REPLY TO QUESTIONS

UNFPA/PER/RFP/001/2022

EXECUTION OF WORKS FOR REMODELING THE UNFPA PERU OFFICES

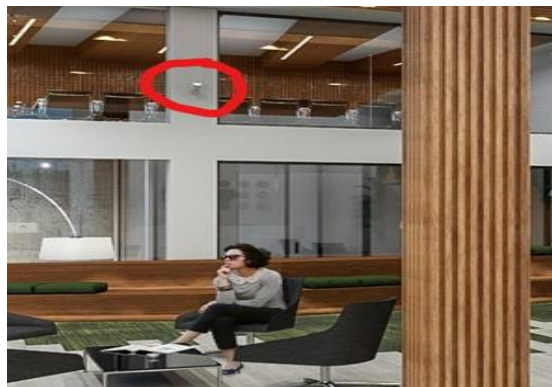
19. In the electrical drawings it is proposed to place lighting fixtures in some columns (see photos), this will require chipping and embedding the respective pipe (as long as they do not complicate the reinforcing steel), confirm this procedure.

It is recommended to place an underlay for the installation of the lighting fixture.

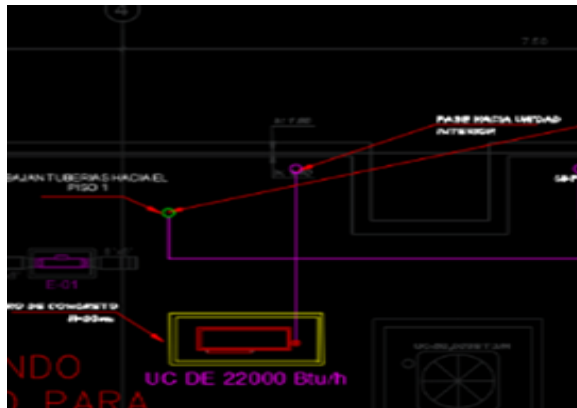
43. Regarding ARCH, ALUMINUM CARPENTRY, 100mm aluminum plinths do not exist (the tallest one is 88mm and is only available in natural matte anodized aluminum)

Indeed, if the 100mm aluminum plinth is not found in the market, it can be replaced by 88mm aluminum plinths. However, to maintain the aesthetic of the design, it is preferable that it is painted matt black.

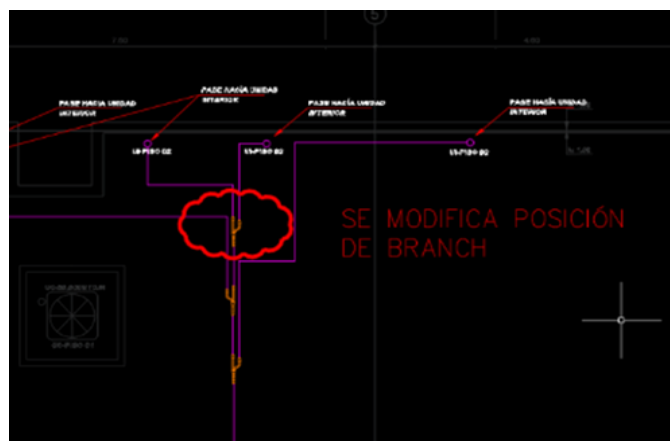
45. On HVAC, MECHANICAL DRAWINGS, A decorative 22,000 BTU/h Split has been added on the roof for the DATA Room. Confirm.

Indeed, it has been added.

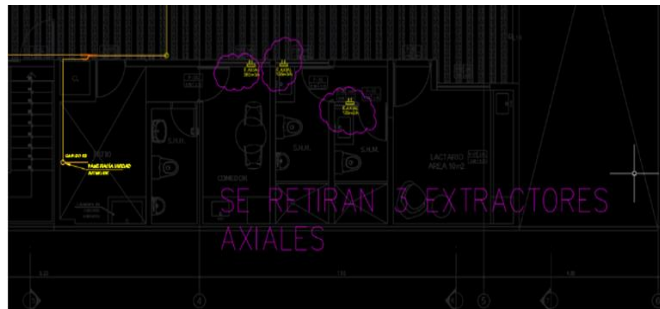
46. Regarding, HVAC, MECHANICAL DRAWINGS, the position of a branches on the roof has been modified. Confirm.

Indeed, it has been added.

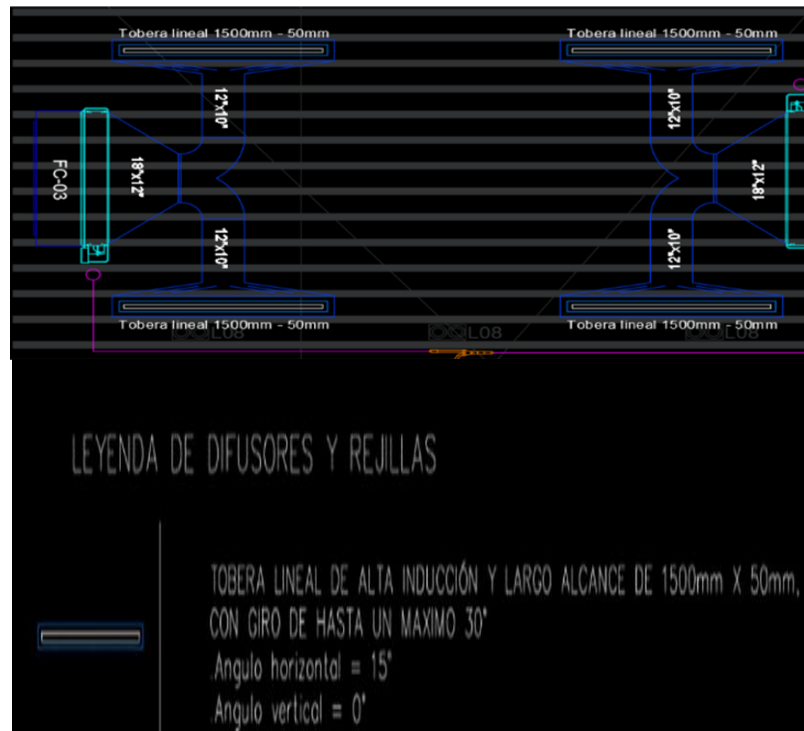
47. Regarding HVAC, MECHANICAL DRAWINGS, On the roof, 03 new axial extractors have been removed from the project for bathrooms, since they currently have existing extractors. Confirm.

Indeed, they are being removed.

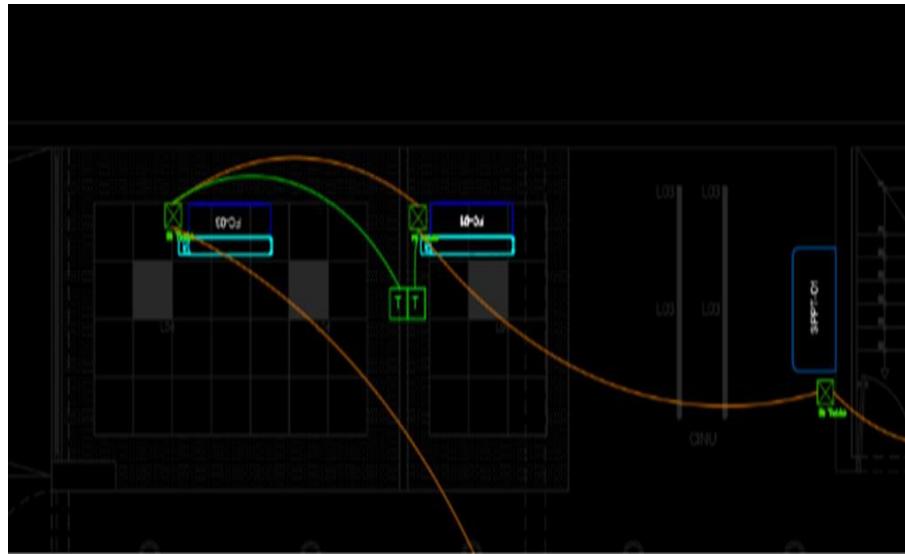
49. Regarding HVAC, MECHANICAL DRAWINGS, can the nozzles be manufactured domestically? Confirm.

Domestic manufacture is confirmed.
